Re: Re-zoning and Development Permit Application: 1400 Fairfield Road and 349/351 Kipling Street  
(Rez No. 00702 & DP No. 000555)

## Appendix A: Summary of Plan Revisions – Direct Responses to the Application Review Summary + Itemized Revision Lists for Architectural, Landscape, Civil (staffed and received November 19, 2021 from July 30, 2021 Re-submission)

## Appendix B: Summary of Plan Revisions – Direct Responses to the Committee of the Whole Meeting (February 11, 2021)

Top: Presented to COTW Feb. 11, 2021

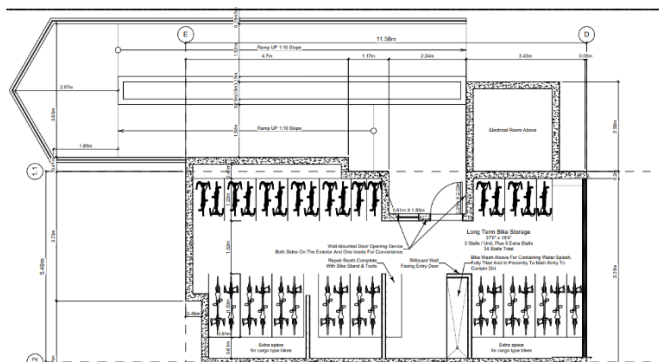
<p><b>Motion 5: ensure the form and character of the development is compatible with the predominant neighbourhood character, consistent with the Design Guidelines for Development Permit Area 15F: Intensive Residential– Attached Dwellings”</b></p>	<p>Several actions have been taken to ensure form and character compatibility. The revised submission now includes the following design elements:</p> <ul style="list-style-type: none"> <li>• Traditional architectural features such as a chimney, wood soffits, and peaked rooflines;</li> <li>• Bay windows and “punch” traditional windows;</li> <li>• Traditional cladding, which includes wood soffits, vertical wood siding, and wood shingles;</li> <li>• Front Porches on Fairfield Rd. and Thurlow Rd. Facades;</li> <li>• Reduced hardscape through clustered parking;</li> <li>• Landscaped front and rear yards;</li> <li>• Limited upper level rear windows to reduce overlook;</li> <li>• A single-family house looking façade along Thurlow Rd., which is currently comprised of primarily single-family homes.</li> </ul> <p>See below a side by side comparison between past versions illustrating the change in form and character:</p>

Bottom: NEW Revised resubmission May 2022.
